Re: Village Board Review of ExteNet's Pending
Chapter 87 Permit Application, SEQRA and ROW Agreement

EXTENET RESPONSES TO VILLAGE BOARD QUESTIONS/COMMENTS
DATED NOVEMBER 10, 2014

Pelham Nodes
Prediction w/PLH003 Cliff & 1st
Ground Elevation = 68ft

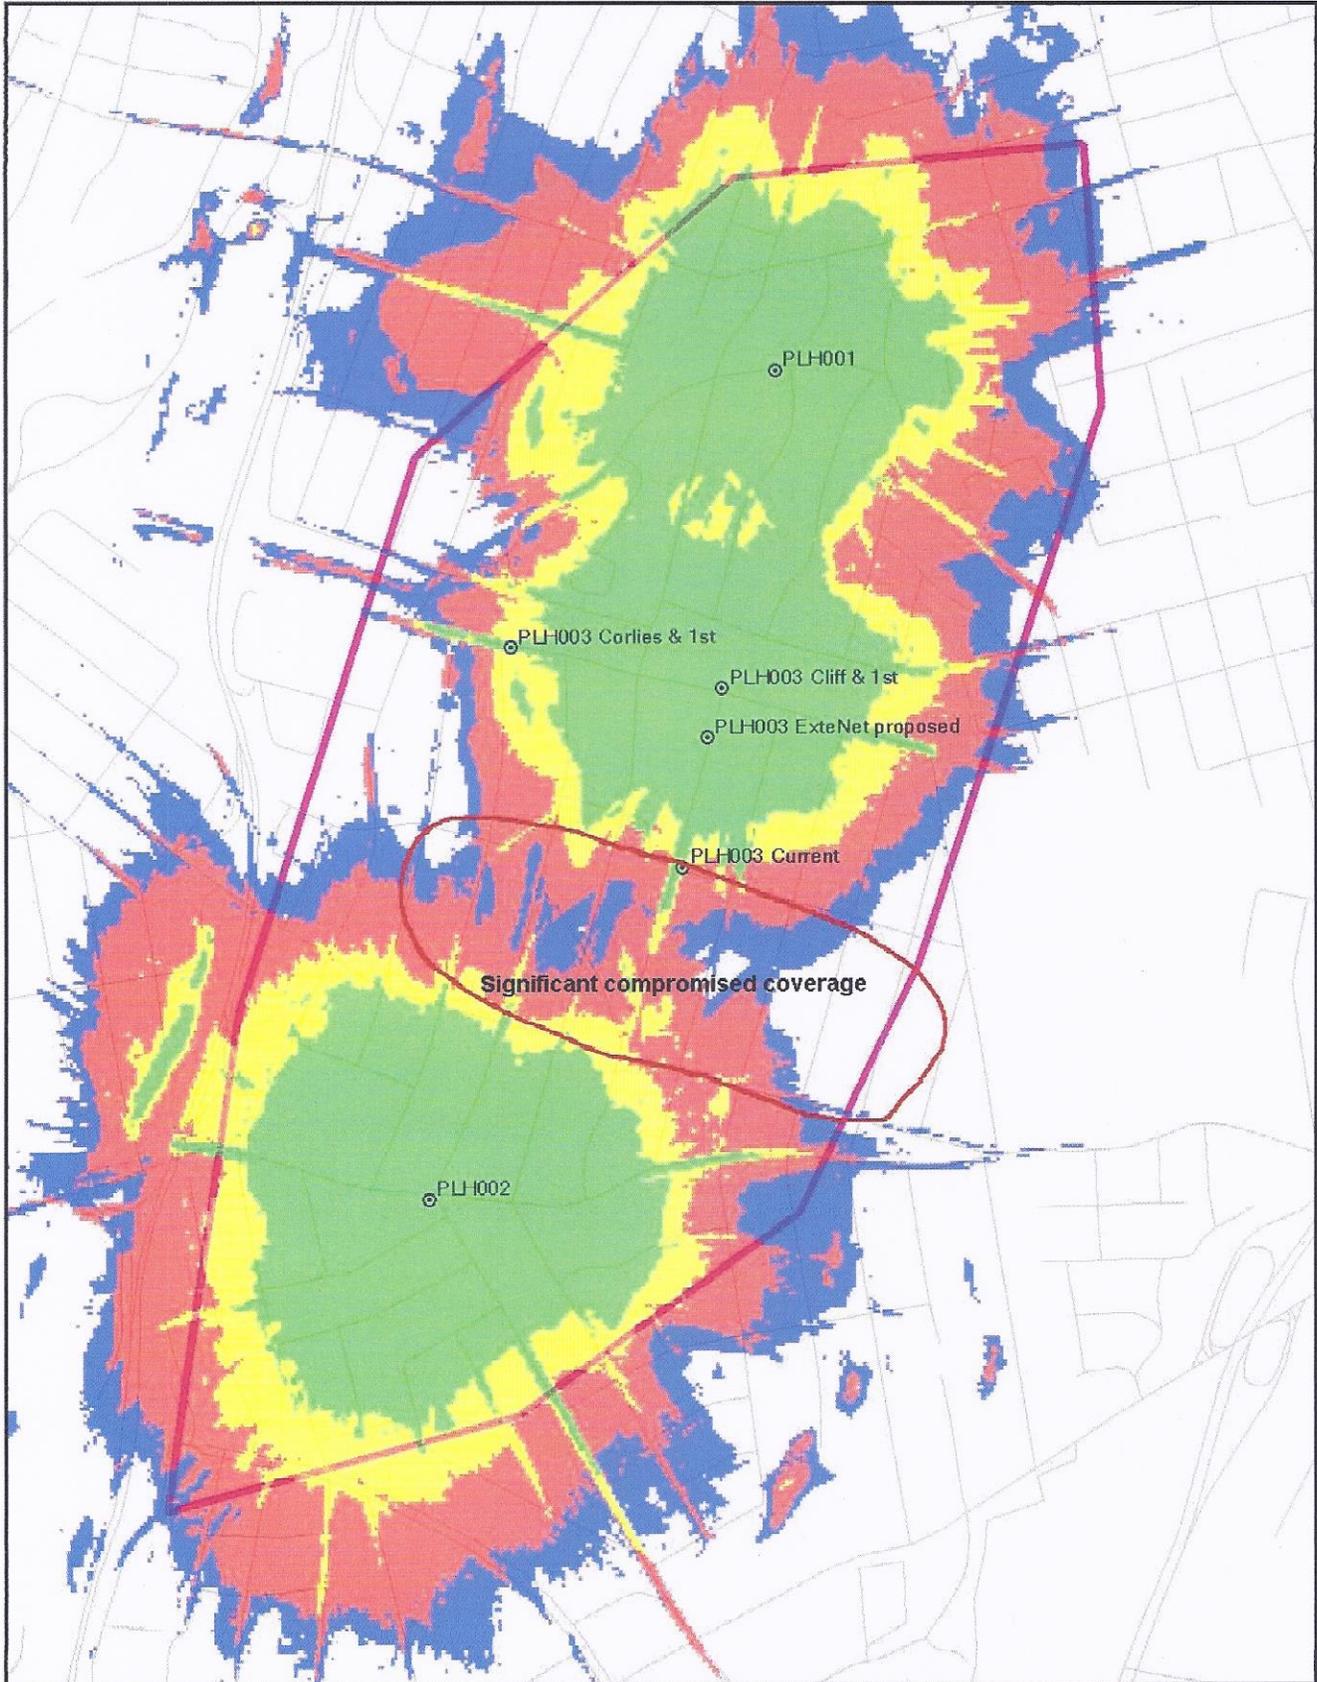
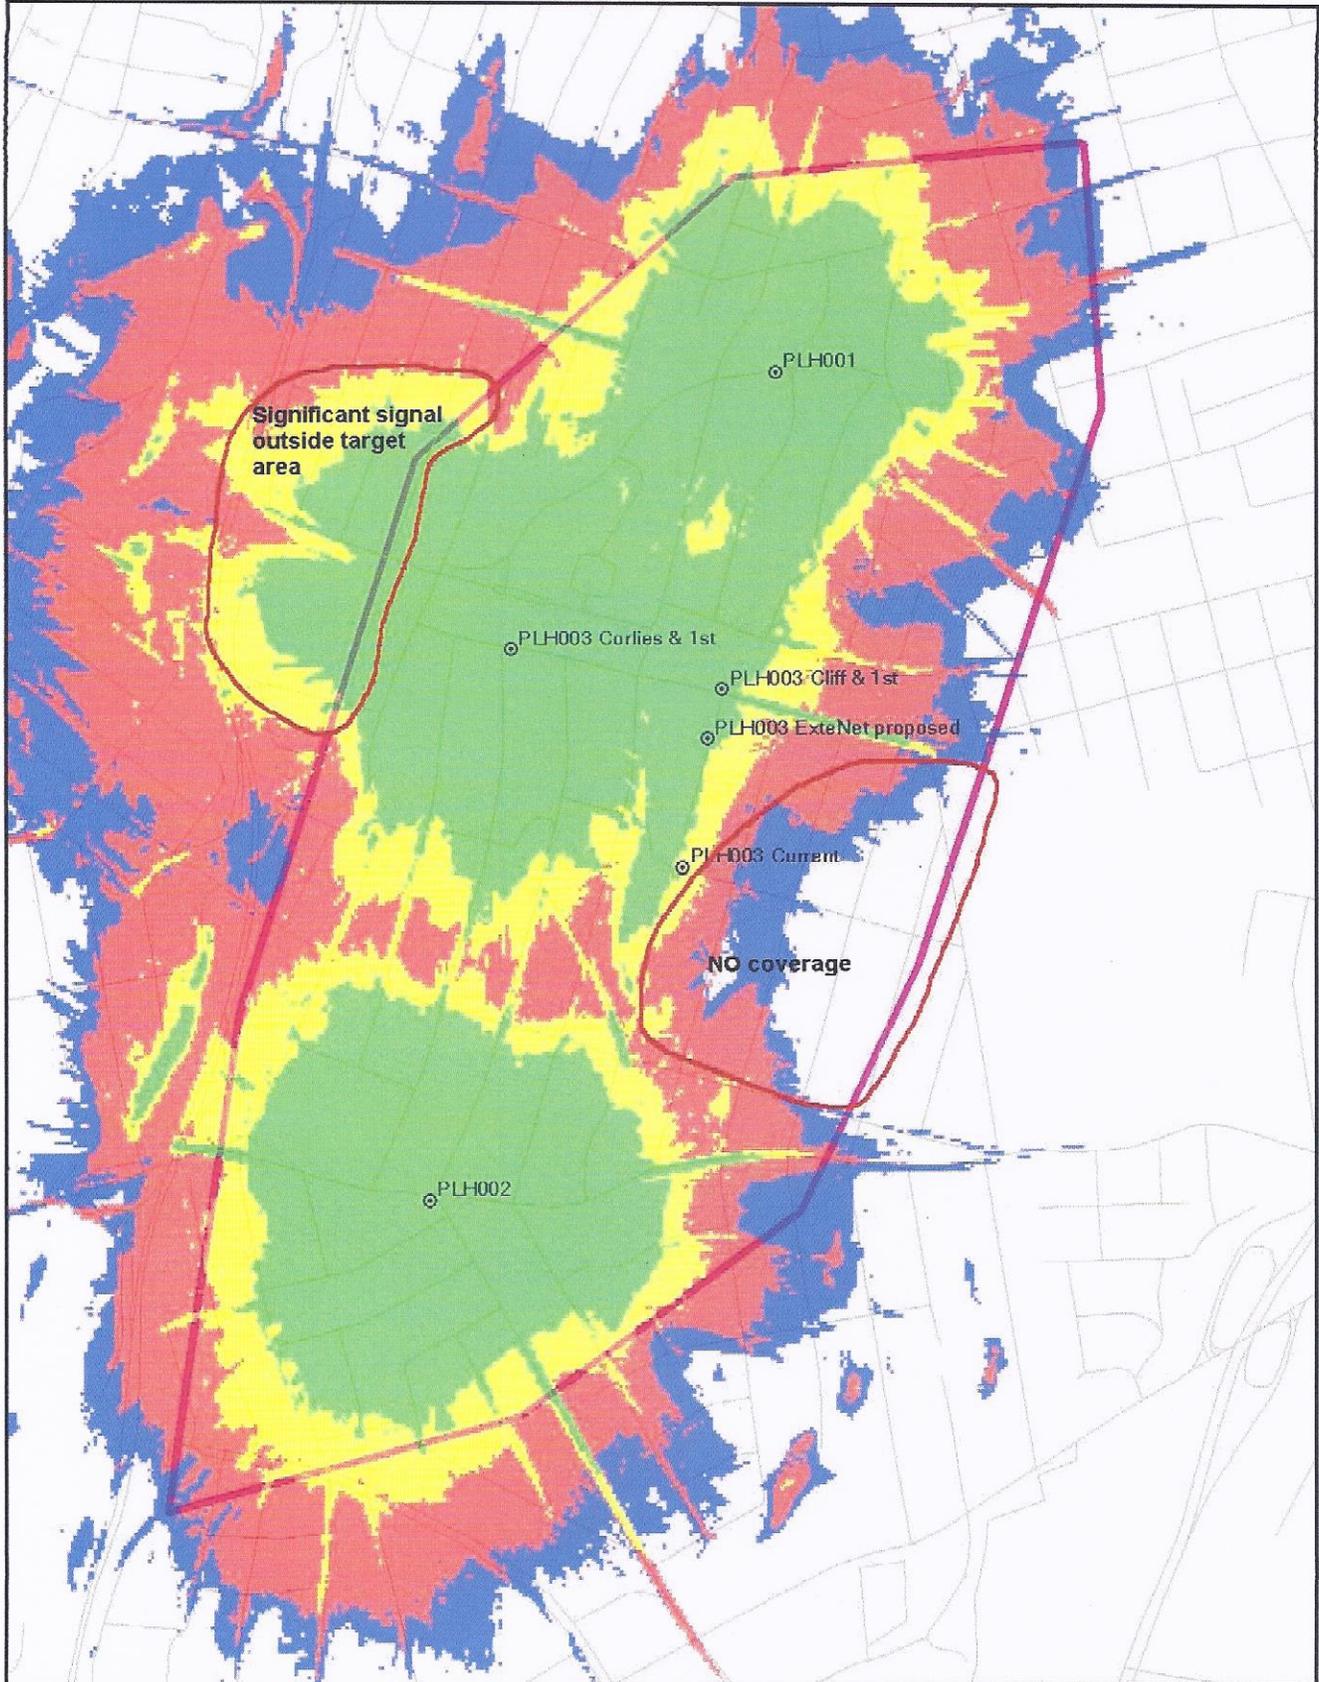
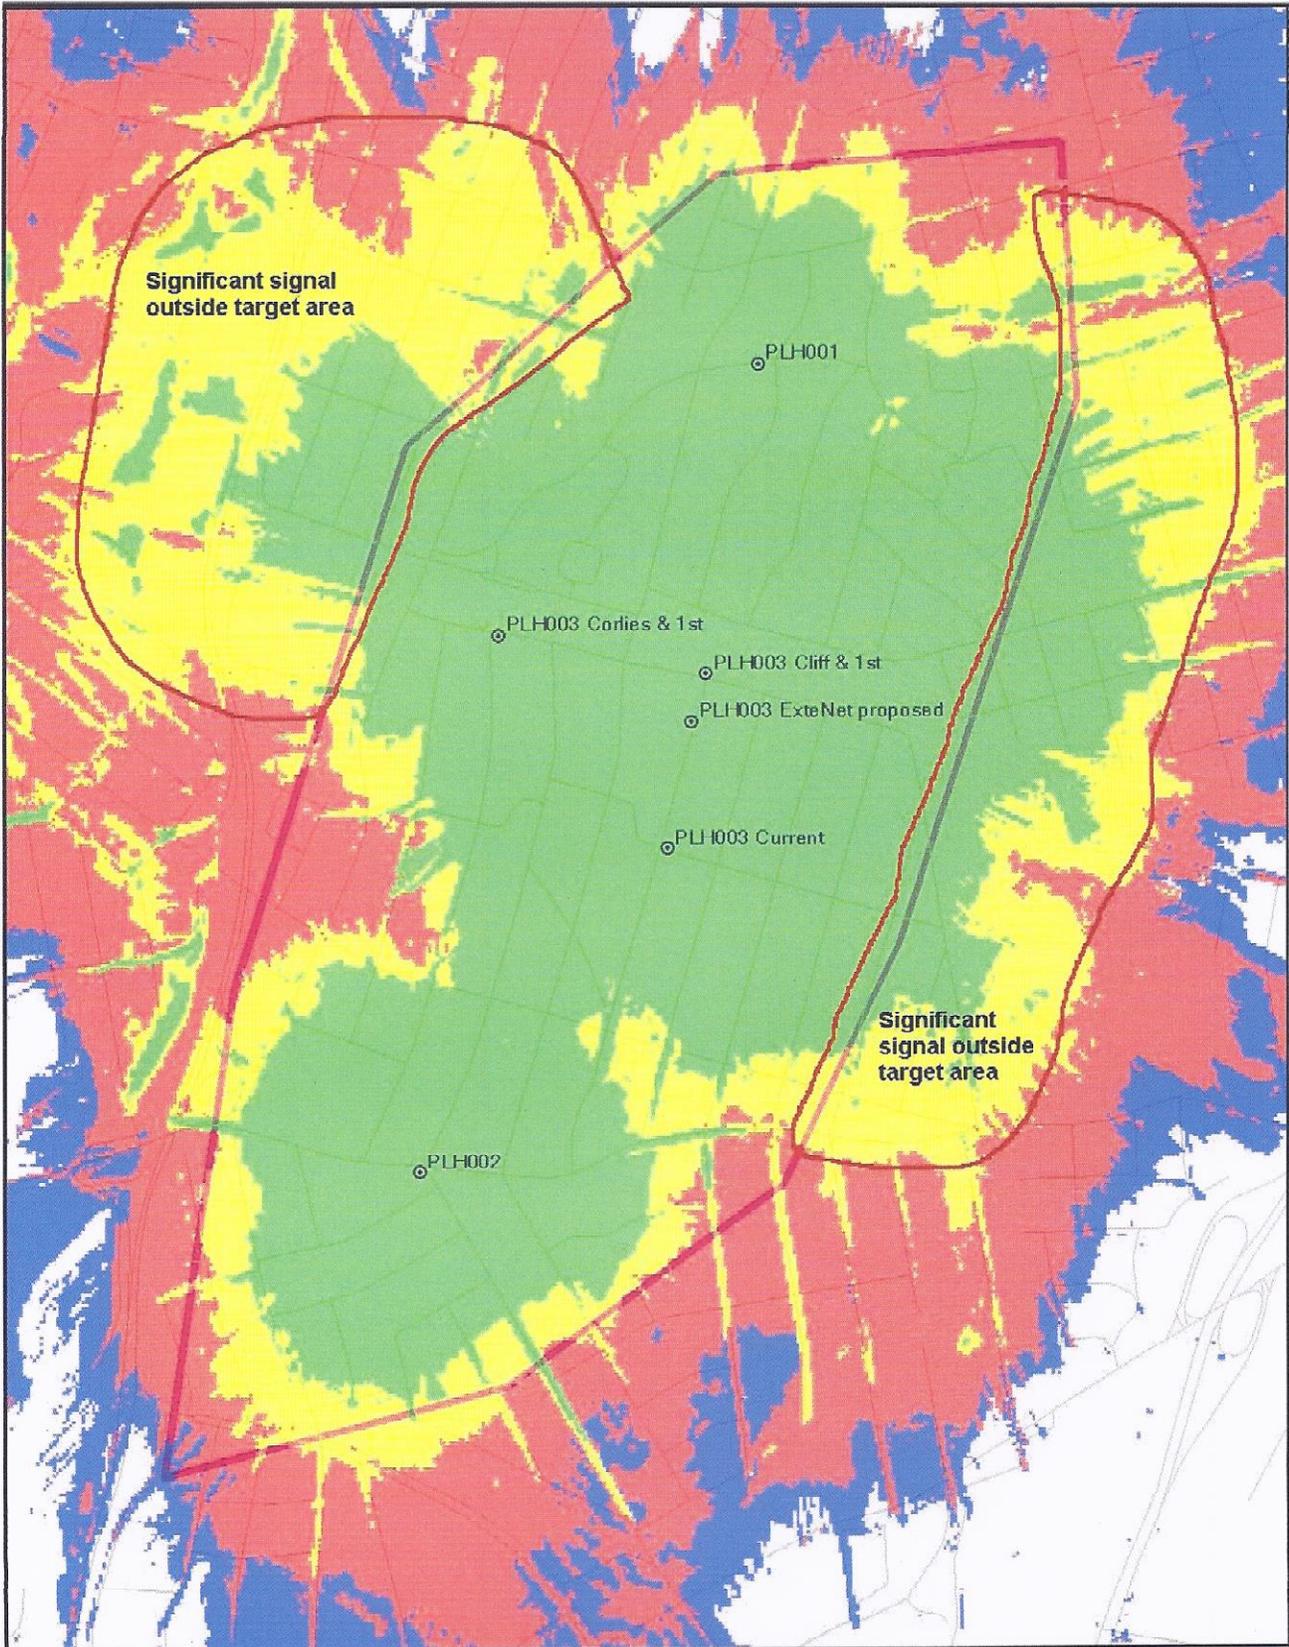
Please provide the details of the potential alternative site that you have identified as well as any potential alternative site in the vicinity of the train station, including the specific location and the necessary height of a pole at those locations.

Please provide some documentation to support the statements made by ExteNet's representatives that a potential site in "the valley" will not substitute for a proposed site "on top of the hill."

Please refer to Figures 1, 2 and 3 in Attachment B for comparisons. Clearly, where the current PLH003 node is located is optimum for service; it is at a relative maximum ground elevation height in its vicinity (105ft) as well as virtually geometrically centered between nodes PLH001 and PLH002 equalizing the coverage between these nodes. Most importantly, it will provide the highest quality of service to more T-Mobile subscribers and other future users of ExteNet's DAS network than if the node were located elsewhere. Of note, not only is an 80ft wood pole in "the valley" by the railroad tracks not practical (or permissible by ConEd), but it causes other potential issues within the network related to interference as noted in Figures 4 and 5. Please also see the supplemental RF report prepared by T-mobile and Mr. Joseph Menio in Attachment C.
